**APPLICATION TO THE RESIDENTIAL DESIGN
AND COMPATIBILITY COMMISSION (RDCC)**

GENERAL MODIFICATION WAIVER

STREET ADDRESS: 2803 Oak Crest Ave., Austin, TX 78704

CITY OF AUSTIN - PLANNING AND DEVELOPMENT REVIEW DEPARTMENT RESIDENTIAL PLAN REVIEW APPLICATION - MASTER COMMENT REPORT

SITE SURVEY

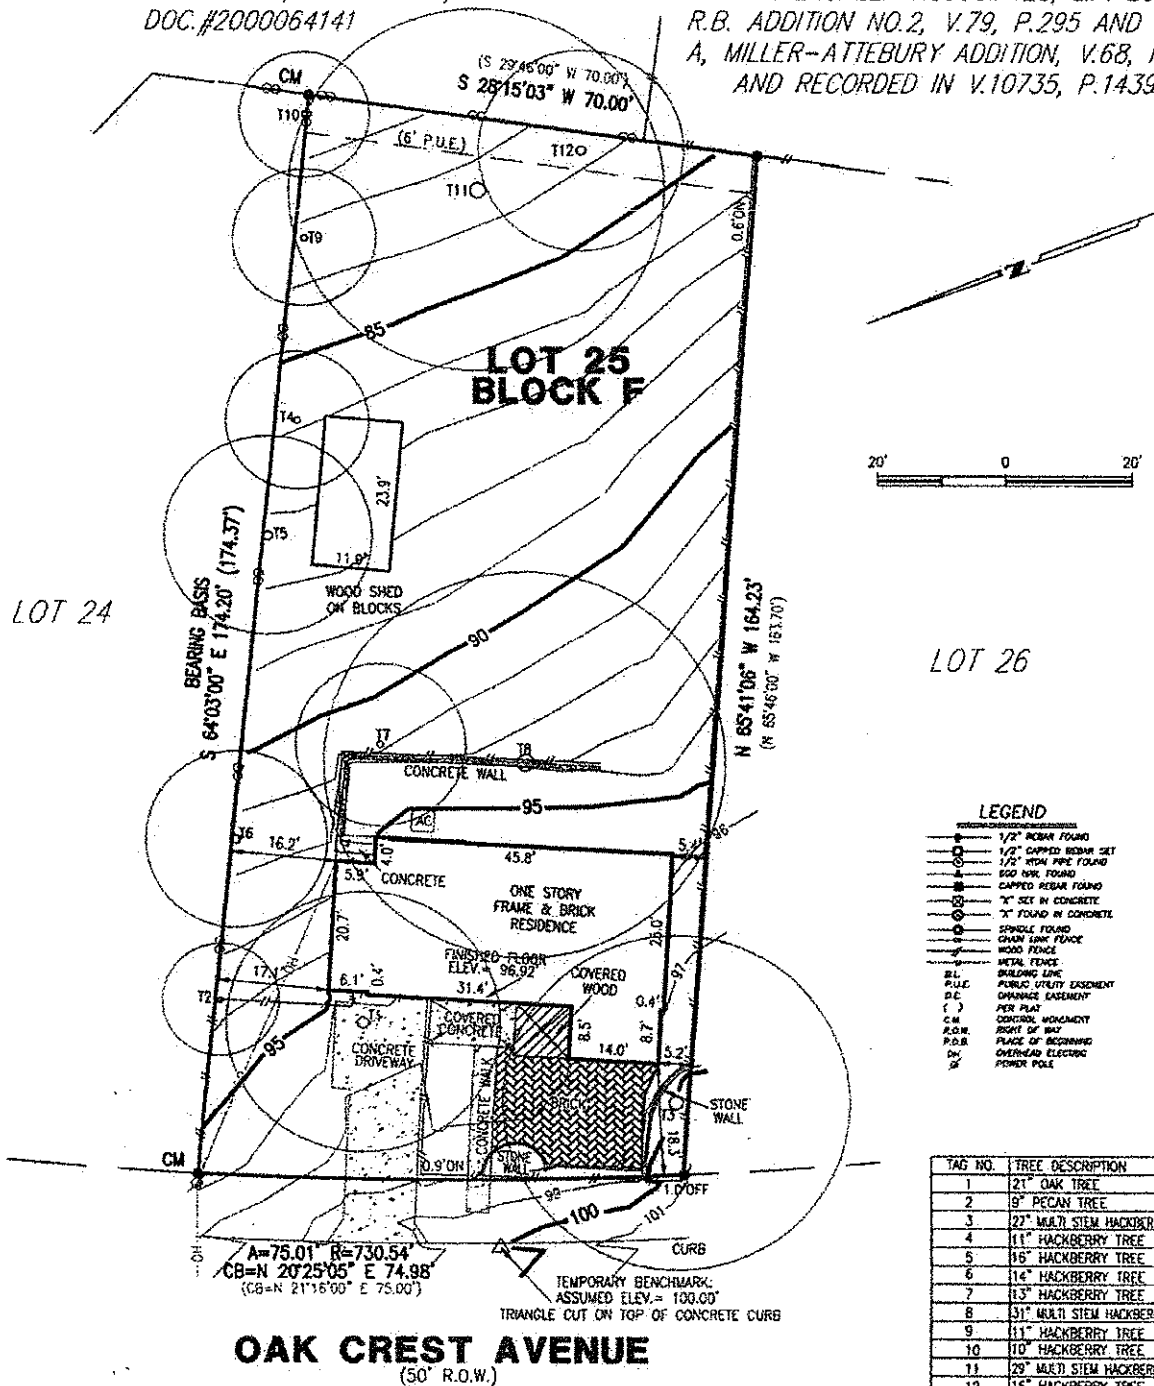
1. The FAR is incorrect: the garage deduction is not allowed and the square footages of areas with ceiling heights more than 15' must be included twice.

2. Provide 6 parking spaces because the building is greater than 4000 square feet. See 25-6-appendix A.
3. A landscape plan is required because the building is greater than 4000 square feet.

4. A fire review is required because the building is more than 3600 square feet.
5. Provide the height of all retaining walls; any retaining wall more than 4' in height is required to have a site plan exemption.

6. Show the outline of both floors of each unit and clearly label accordingly on the site plan.
7. Provide sidewalks per section 25-6-3.4
8. A minimum driveway width of 15' at the property line is required for a duplex.

9. The following information must be included on the site plan and elevations in order to confirm compliance with the McManis Ordinance:
 - o high adjacent grade at building

- o low adjacent grade at building
 - o Average adjacent grade at building
 - o McManis setback intervals with spot grades at each corner and high point on all elevations

- o Building setback line on plot plan

- o Building heights dimensioned from average elevation to the proper point on roof sections
10. Additional comments may be generated as a result of the resubmittal.

Site Plan

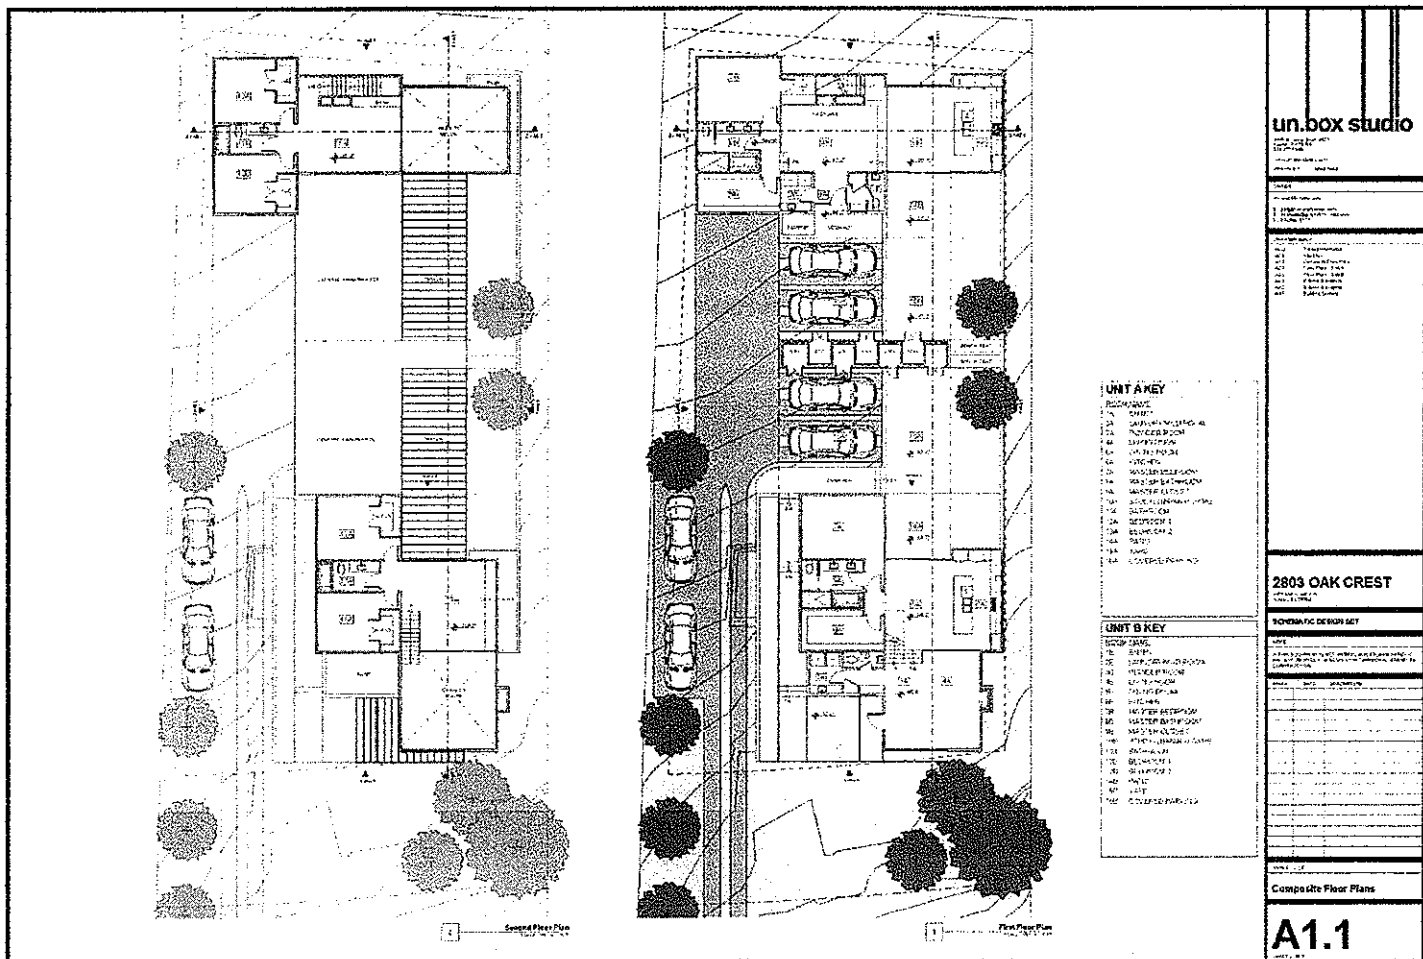
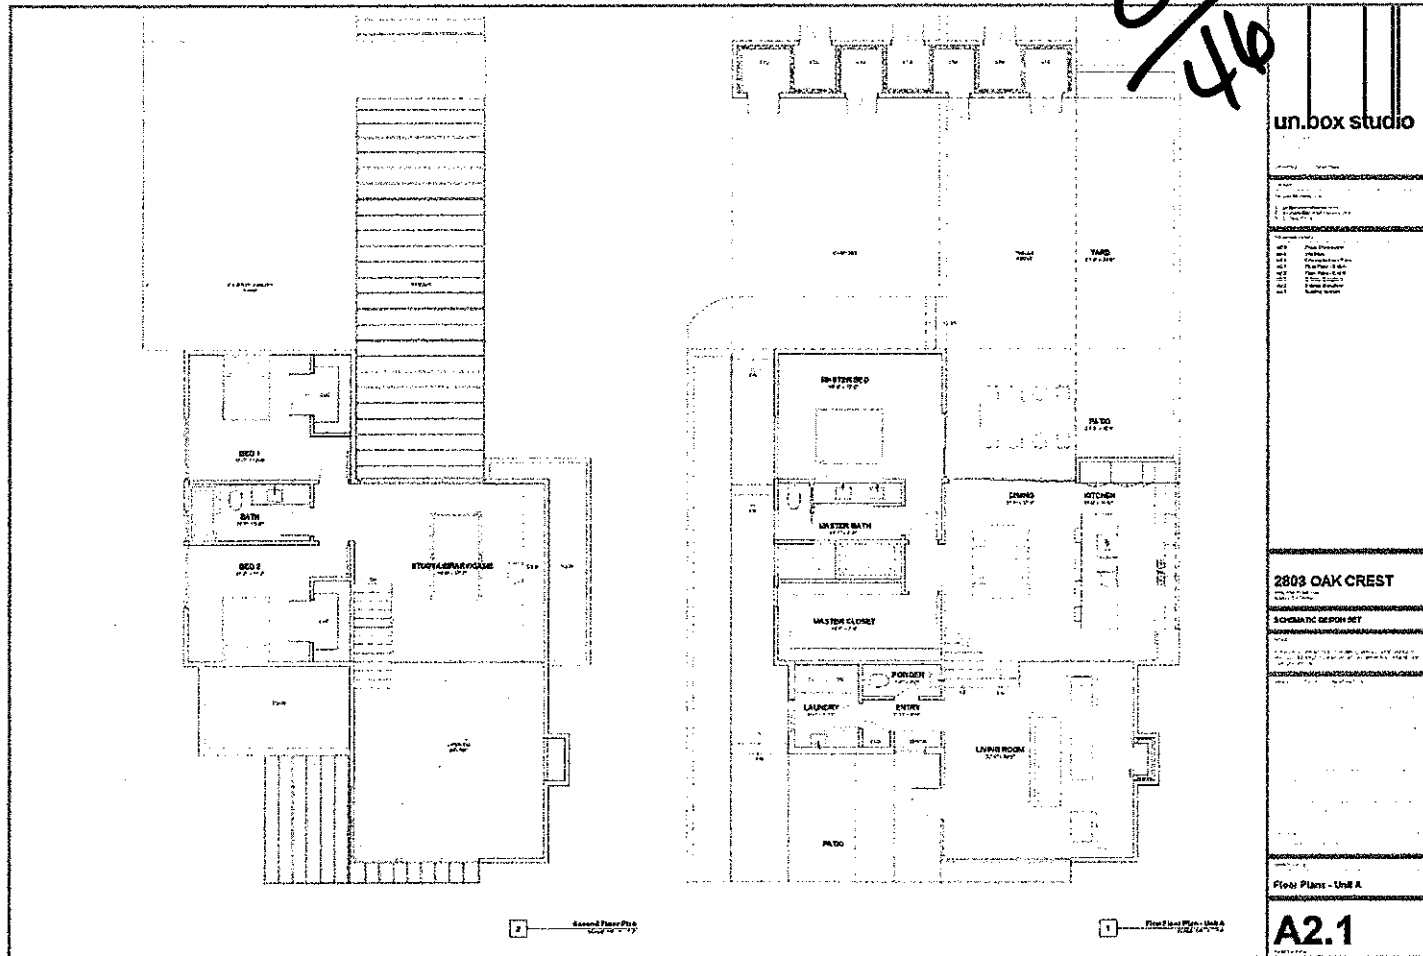
I will not approve this design based on the following:

(D) The two dwelling units are subject to the following requirements:

(1) The two units must have a common floor and ceiling or a common wall, which may be a common garage wall, that:

(a) extends for at least 50 percent of the maximum depth of the building, as measured from the front to the rear of the lot; and

(b) maintains a straight line for a minimum of four foot intervals or segments.

(2) The two units must have a common roof.

(3) At least one of the two units must have a front porch that faces the front street and an entry to the dwelling unit, except that units located on a corner lot must each have a front porch that faces a separate street and an entry to the dwelling unit.

(4) The two units may not be separated by a breezeway, carport, or other open building element.

Thank you for your quick response earlier. We have been working all morning/afternoon to try and work out a solution. We are now showing that the units are separated by an enclosed garage (see attached). Hopefully this still meets COA regulation requirements.
